**SUNDRY NOTICES AND REPORTS ON WELLS**  
**Do not use this form for proposals to drill or to re-enter an abandoned well. Use Form 3160-3 (APD) for such proposals.**

Changes to Approved Plan  
ConocoPhillips Company  
Maljamar, Grayburg-San Andres

MCA Unit 477

ConocoPhillips Company respectfully requests approval to change an approved plan due to utilizing a different rig. The revised portions of the plan include: the pressure control equipment, the proposed mud systems, diagram and schematic for BOP and choke manifold equipment, location schematic and rig layout, and updated H2S contingency plan. This request is made under the provisions of Onshore Order No. 2 and No. 6.

# Attachment # 1

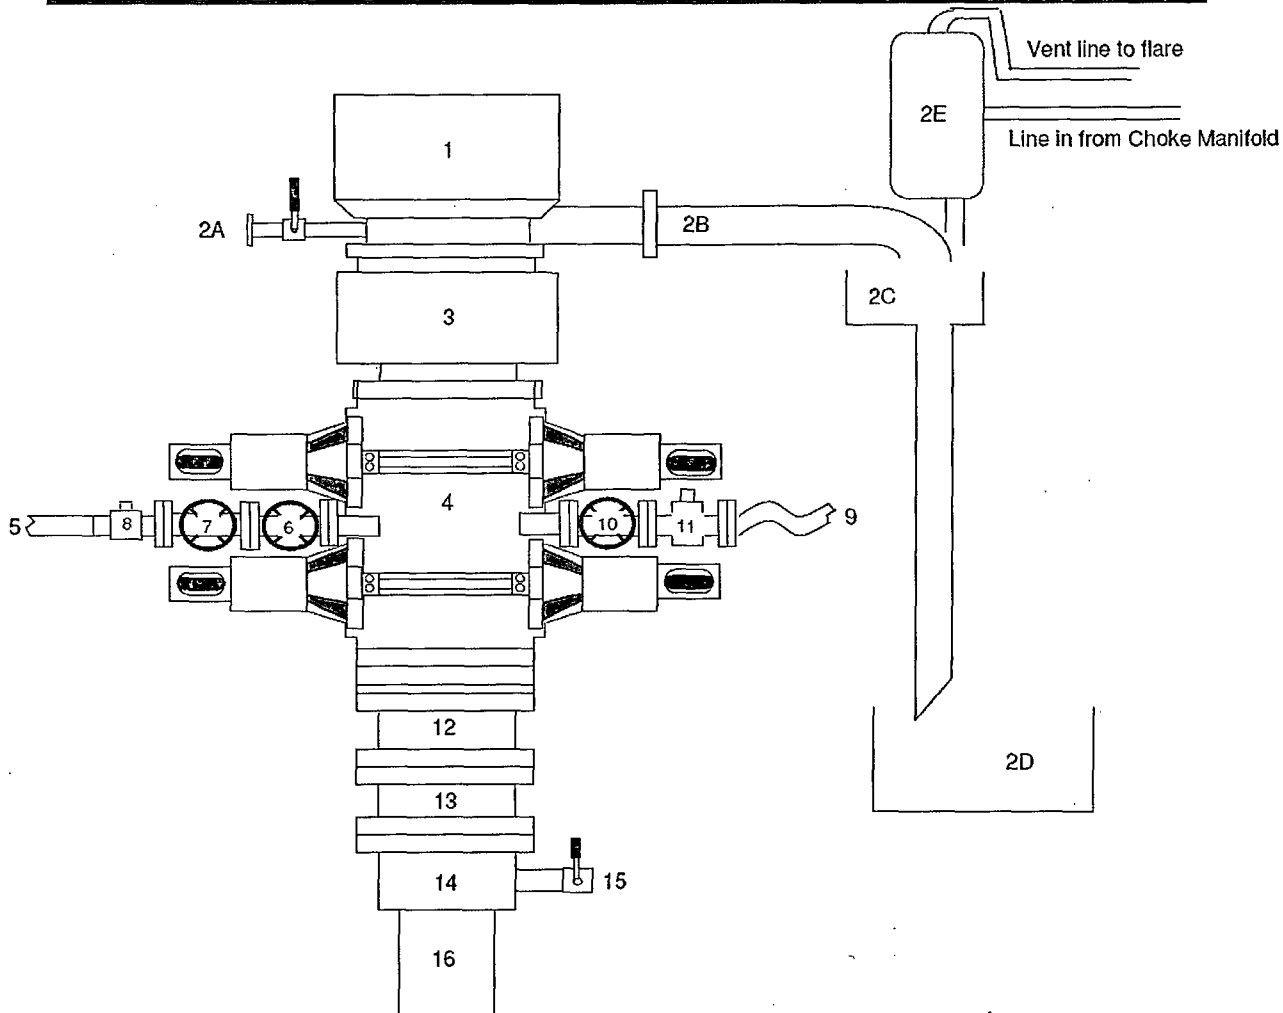
A 11" 3M system will be installed, used, maintained, and tested accordingly as described in Onshore Oil and Gas Order No. 2.

- o Rotating Head
- o Annular BOP, 11" 3M
- o Blind Ram, 11" 3M
- o Pipe Ram, 11" 3M

# CHOKE MANIFOLD ARRANGEMENT

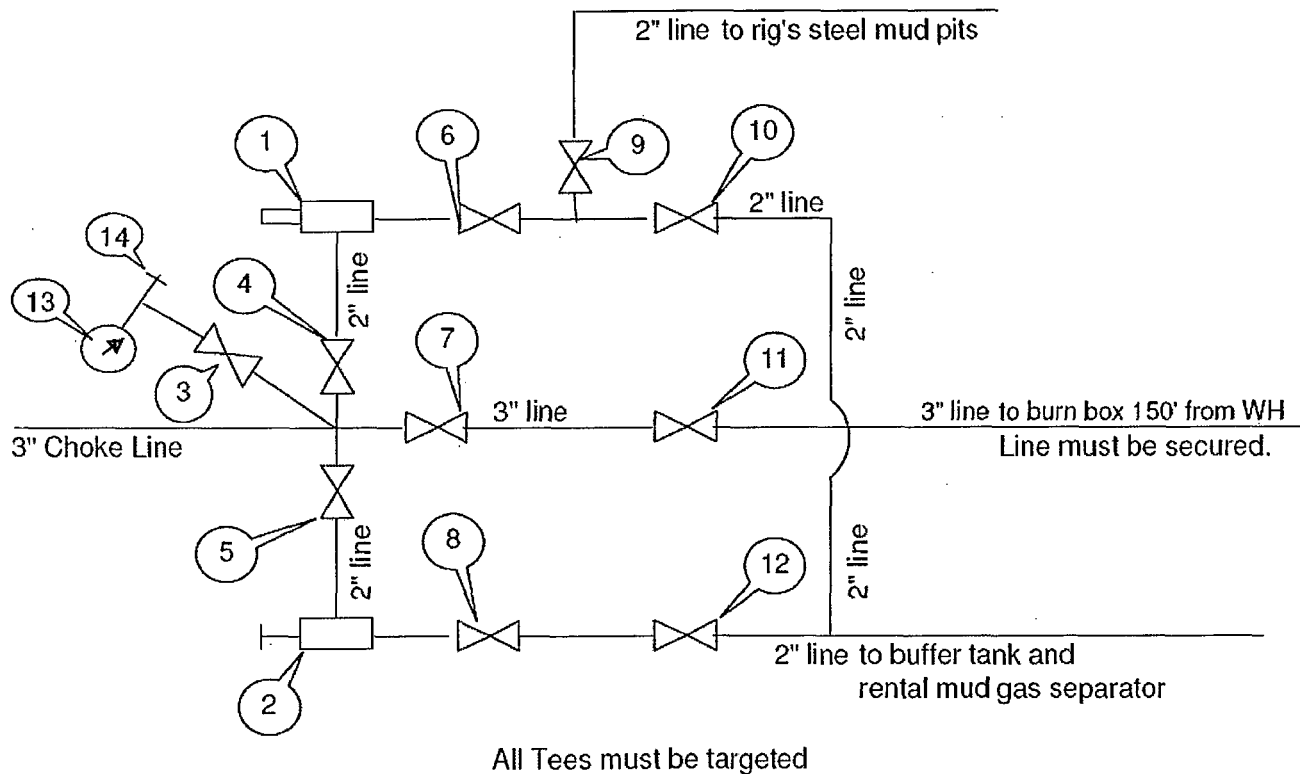
We will test each valve to 3000 psi from the upstream side.

ConocoPhillips Company respectfully requests a variance to install a flexible choke line instead of a straight choke line prescribed in the Onshore Order No. 2, III.A.2.b Minimum standards and enforcement provisions for choke manifold equipment. This request is made under the provision of Onshore Order No. 2, IV Variances from Minimum Standard. The rig to be used to drill this well will be equipped with a flexible choke line if the requested variance is approved and determined that the proposed alternative meets the objectives of the applicable minimum standards.

The applicability of the flexible choke line will reduce the number of target tees required to make up from the choke valve to the choke manifold. This configuration will facilitate ease of rig up and BOPE Testing.

1. Variance approved to use flex line from BOP to choke manifold. Check condition of flexible line from BOP to choke manifold, replace if exterior is damaged or if line fails test. Line to be as straight as possible with no hard bends and is to be anchored according to Manufacturer's requirements. The flexible hose can be exchanged with a hose of equal size and equal or greater pressure rating. **Anchor requirements, specification sheet and hydrostatic pressure test certification matching the hose in service, to be onsite for review.** If the BLM inspector questions the straightness of the hose, a BLM engineer will be contacted and will review in the field or via picture supplied by inspector to determine if changes are required (operator shall expect delays if this occurs).
